**COUNCIL OF  
THE EUROPEAN UNION**

**8385/12**

Subject: COMMISSION DECISION of XXX amending Commission Decisions  
2006/861/EC, 2008/163/EC, 2008/164/EC, 2008/217/EC, 2008/231/EC,  
2008/232/EC, 2008/284/EC, 2011/229/EU, 2011/274/EU, 2011/275/EU,  
2011/291/EU and 2011/314/EU concerning technical specifications for  
interoperability (omnibus part 3)

**COMMISSION DECISION**

“Figure N1

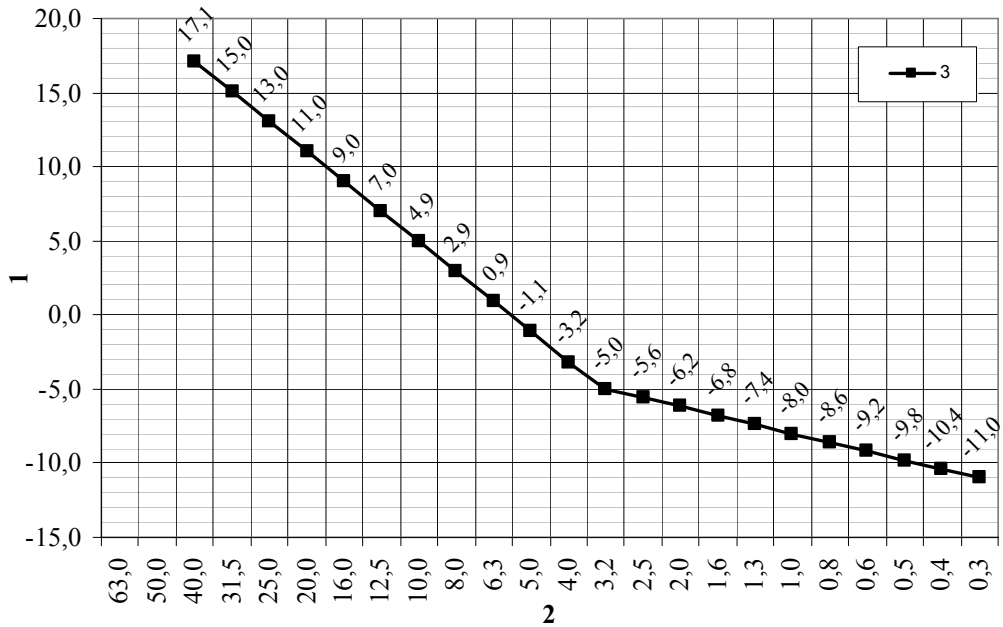
(33) In Annex N, figure N1 is replaced by the following:
